Subject: San Joaquin Solar 1 LLC and San Joaquin Solar 2 LLC  
Fresno County, California 08-AFC-12

# **San Joaquin Solar 1 & 2 Hybrid Project**

**Initial Response to CEC Data Request**

**Set #1, 08-AFC-12**

# EXHIBIT A

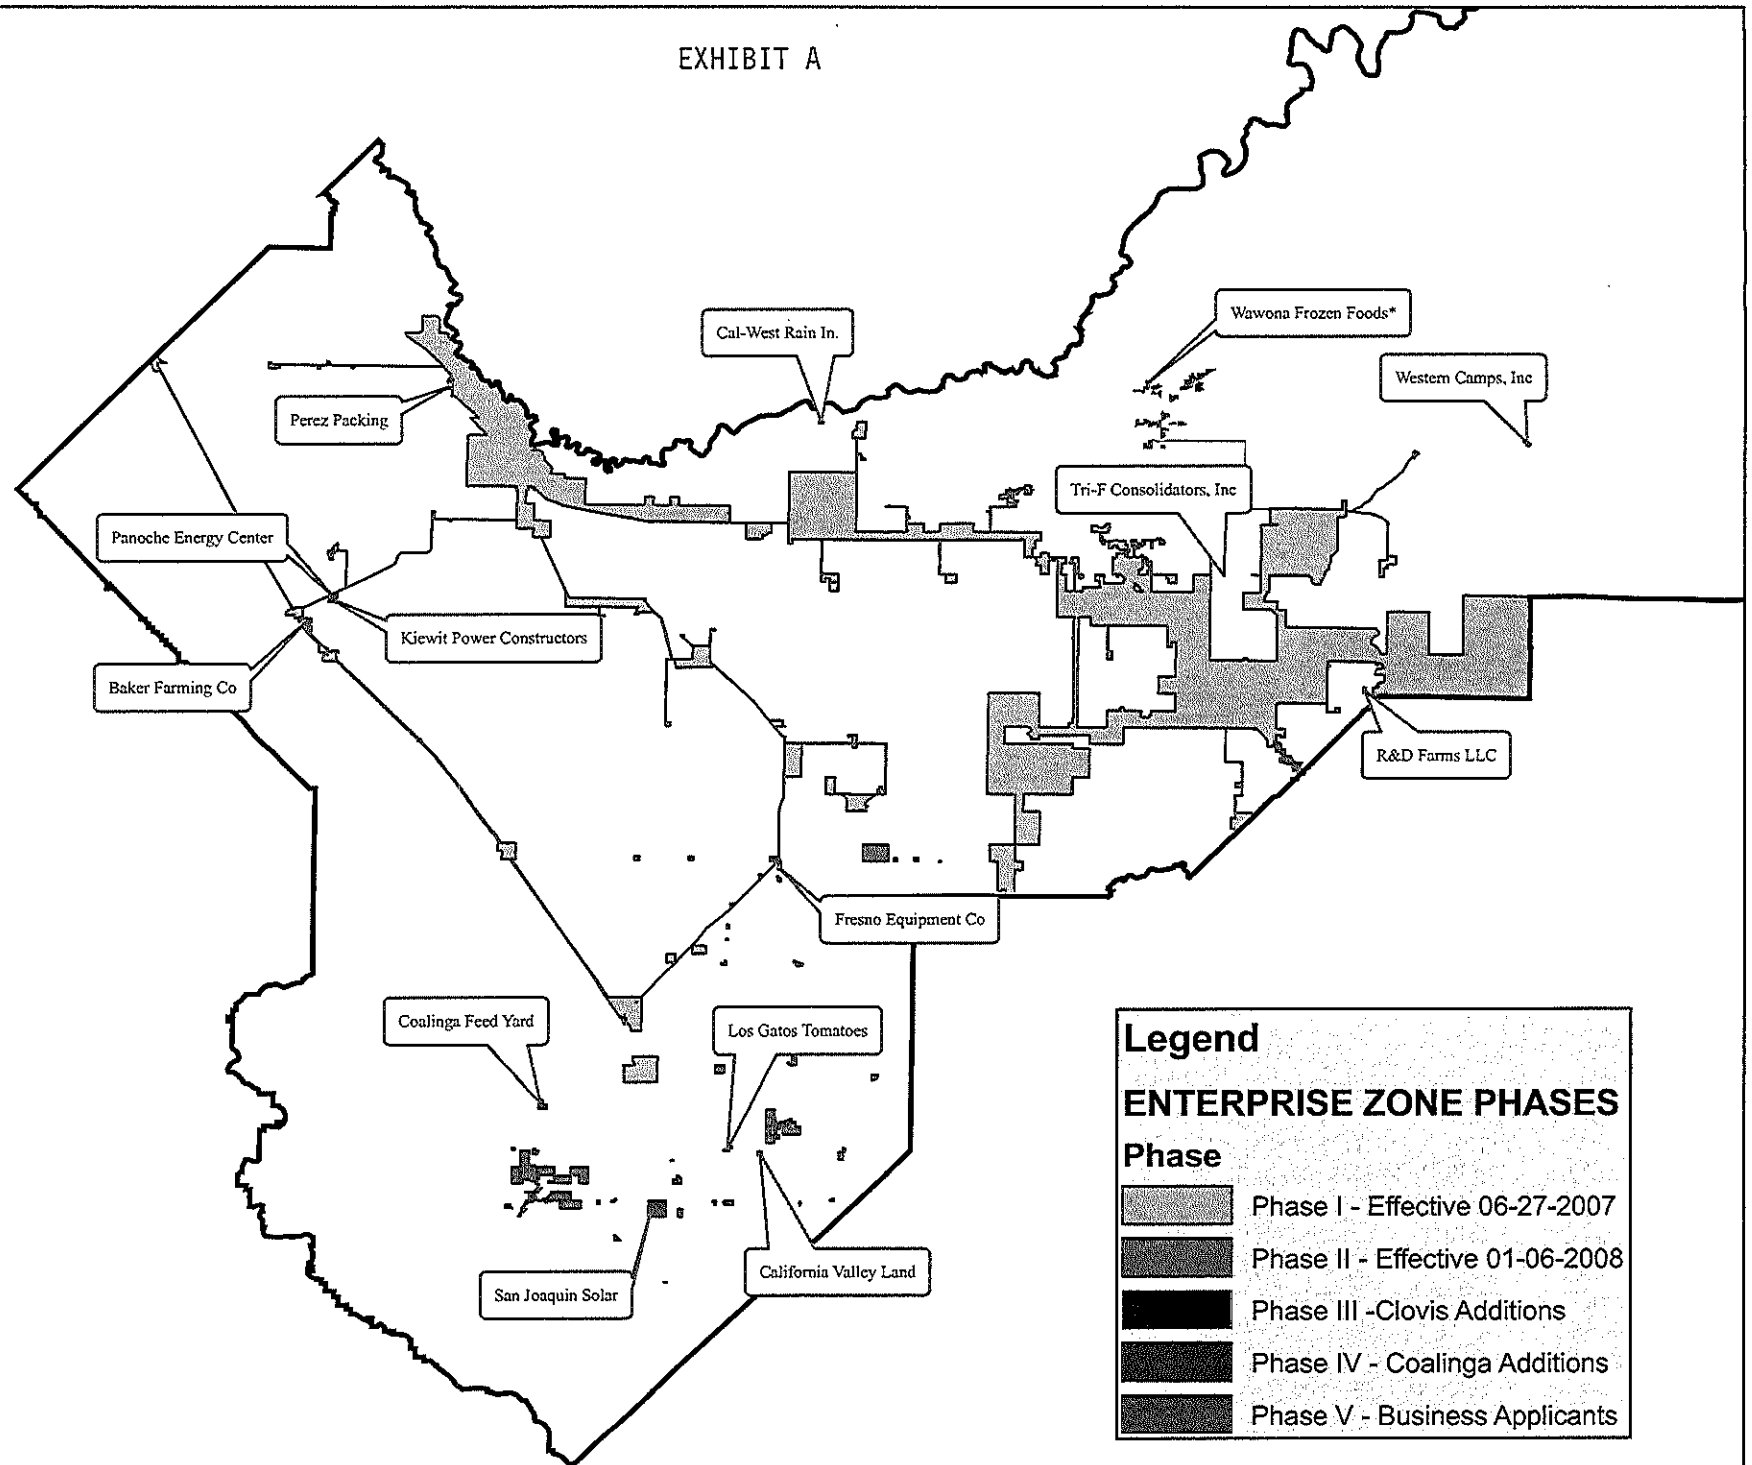
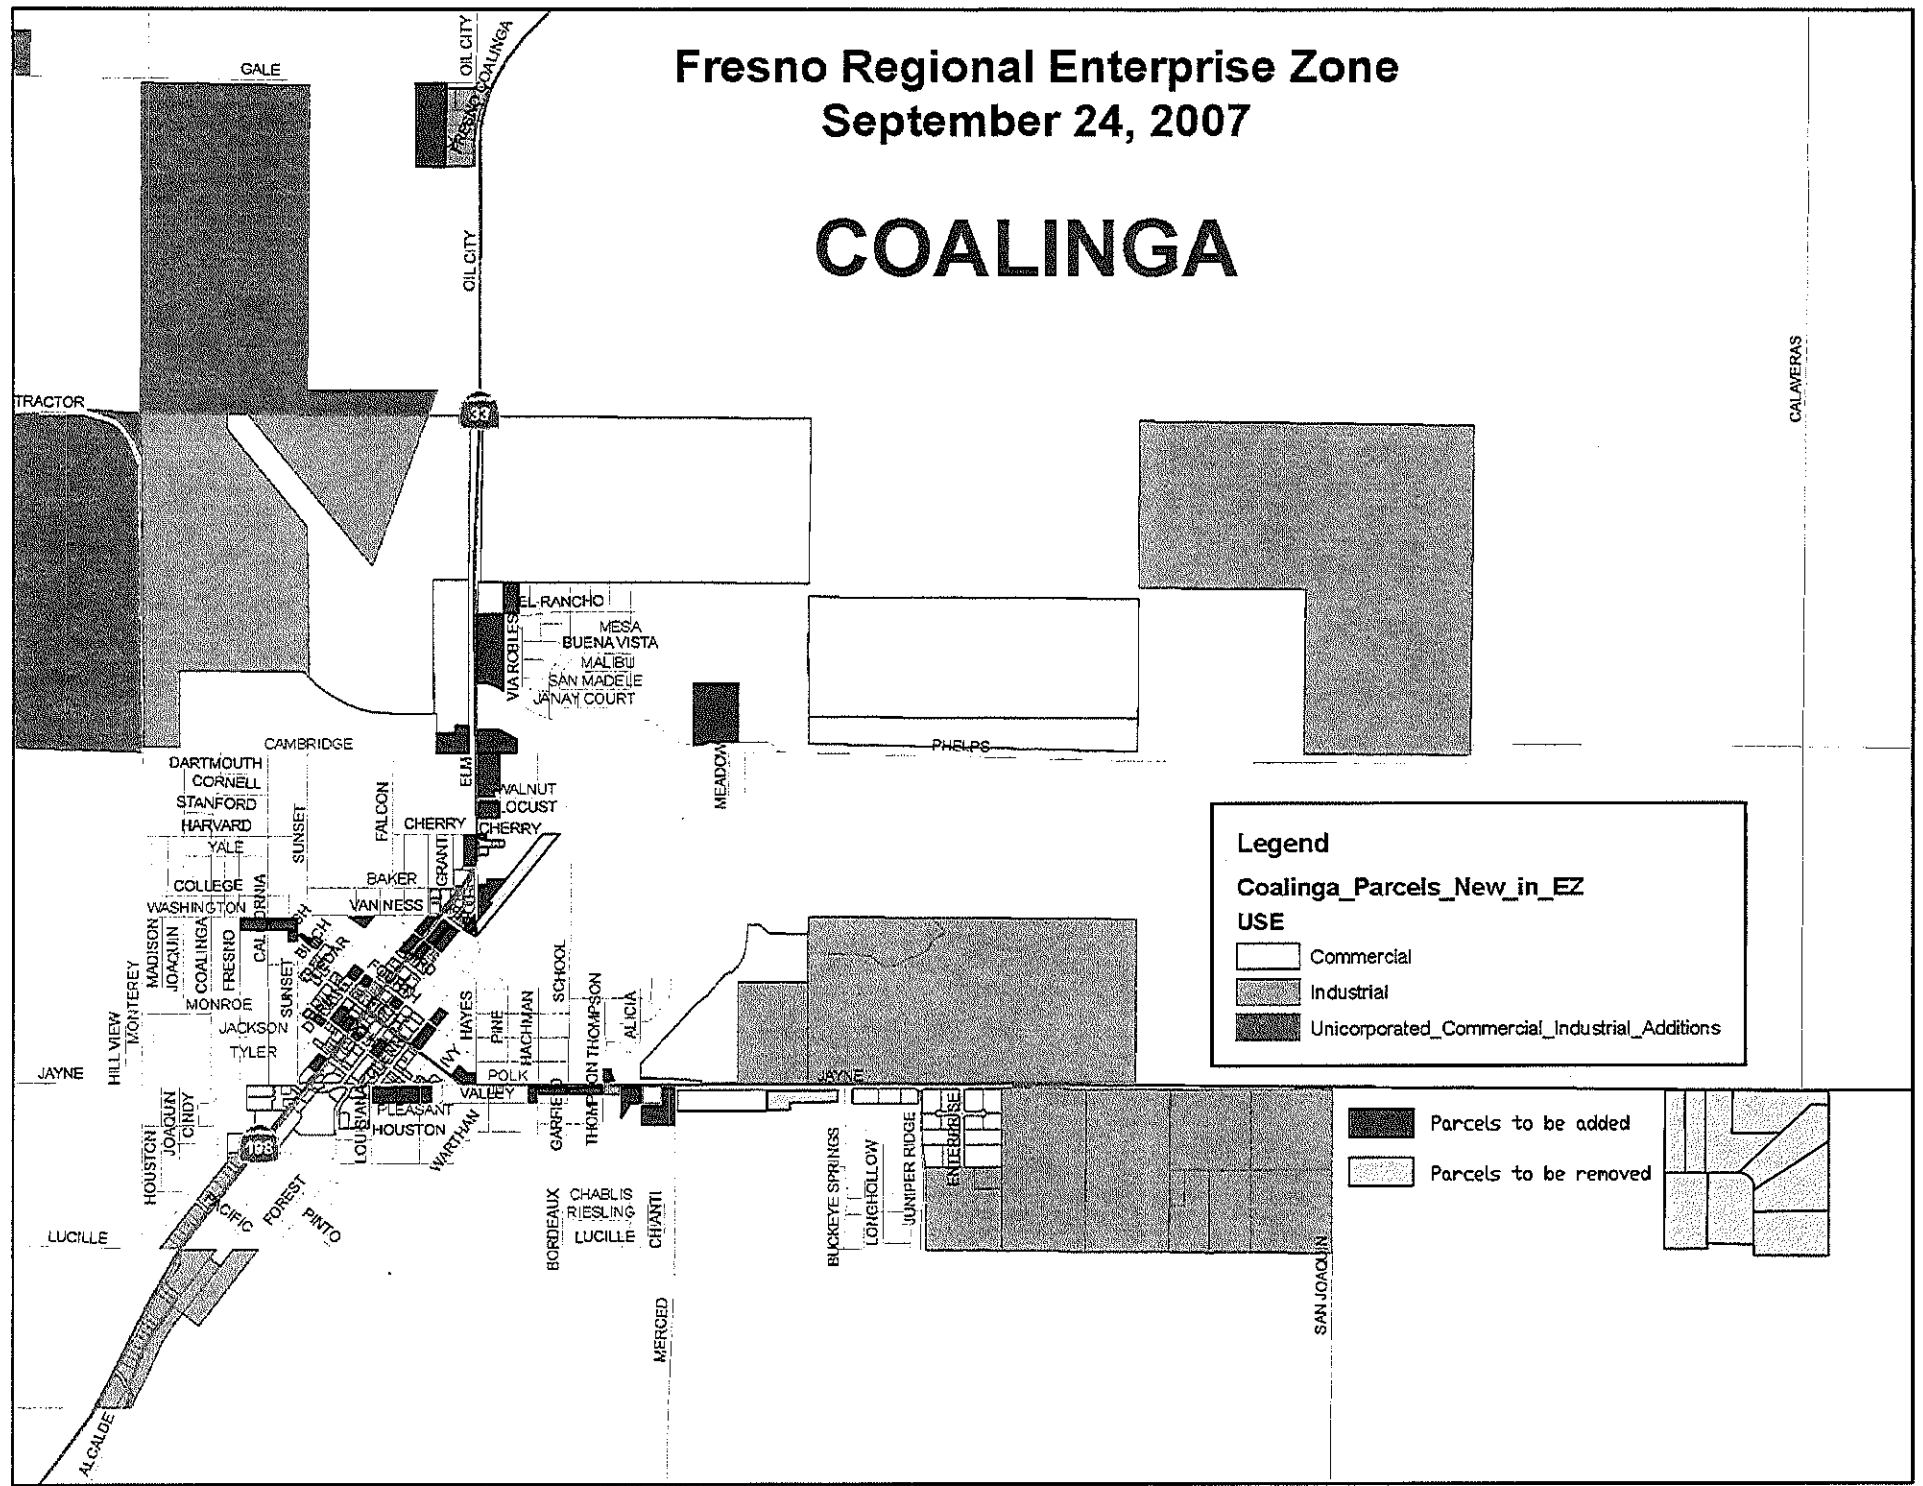
Because a Williamson Act Contract is the legal document that obligates the property owner, and any successors of interest, to the contract's enforceable restrictions, please provide documentation that the Fresno County Board of Supervisors (or the Housing and Community Development Department) adopted (or approved) the project site as an Enterprise Zone.

Documentation from the Fresno County Board of Supervisors is presented in the following pages.

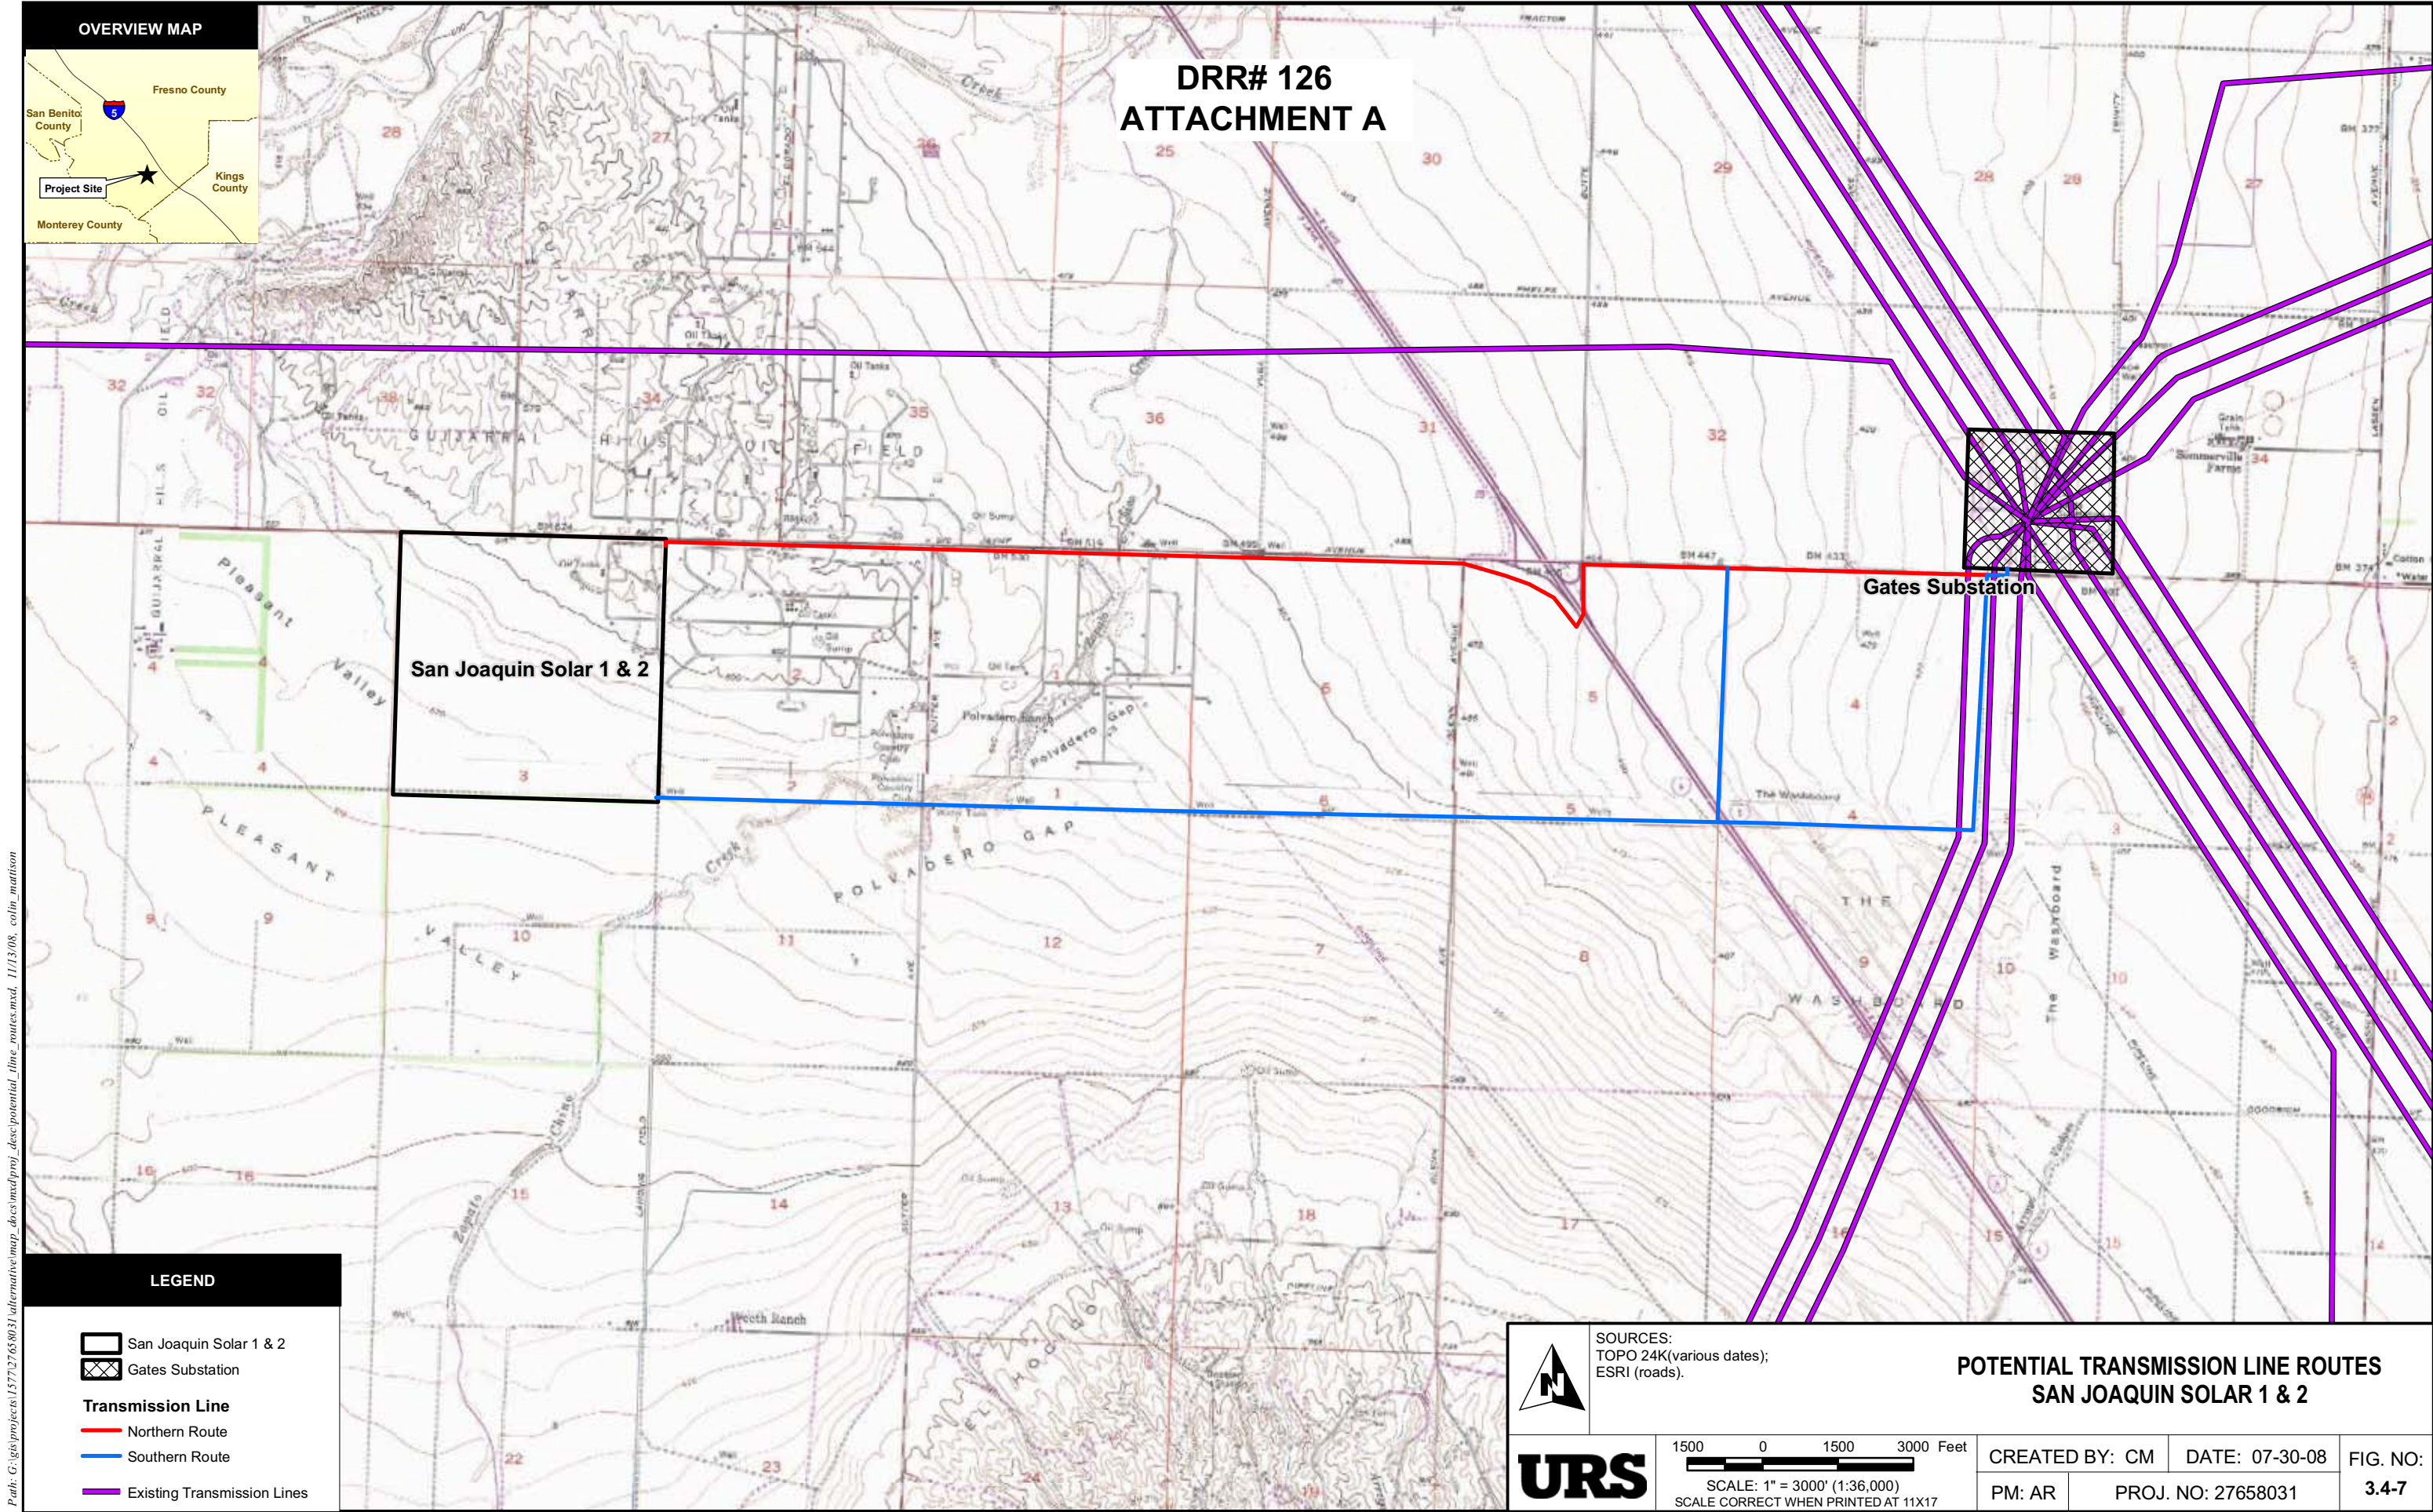
A. Please prepare a photo simulation of the transmission line crossing of the I-5 vicinity from a Key Observation Point (KOP) located within the Fresno County scenic highway corridor of I-5. The KOP should be located where the transmission line crossing (and any associated structures), would be most visible to I-5 travelers.

B. Given the potential for an underground placement of the I-5 crossing of the transmission line, please provide a photo simulation of the transmission area from above ground to underground.

A. A KOP for travelers along I-5 was not selected with the concurrence of CEC siting staff, due to (1) likely traveler inability to distinguish the presence of an additional transmission line crossing at that location, as well as (2) short viewing durations of the Project's transmission line.

(1) There are numerous existing transmission lines currently crossing I-5 both north and south of the Project's proposed transmission line (see Attachment A, next page) which reduces viewer sensitivity to the presence of additional overhead transmission lines in the area.

(2) Viewer is traveling at a high rate of speed perpendicular to Project transmission line, which provides for short viewing durations, reduces visibility and sensitivity.

KOP#4 was selected to represent worst-case, and/or the most unobscured and longest duration, views to the proposed transmission line route and interconnection for travelers along West Jayne Avenue and in the Project area. For this KOP, the viewer is traveling parallel to the proposed transmission line which provides for longer viewing durations in comparison to a perpendicular traveler. KOP#4 is representative of travelers and how they would view an additional transmission line. For these reasons, and per URS coordination with Mark Hamblin in June and July of last year (06/2008-07/2008), a KOP depicting the Project's transmission line crossing of I-5 is not necessary to assess the visual impacts of this project.

B. As discussed in Section 3.0, Project Description, of the AFC, the two potential transmission line routes that have been identified (see Figure 3.4-7) include overhead lines. The Project's transmission line is proposed to cross over I-5 as proposed in the AFC. The applicant has not amended the AFC Project description to conduct another action.
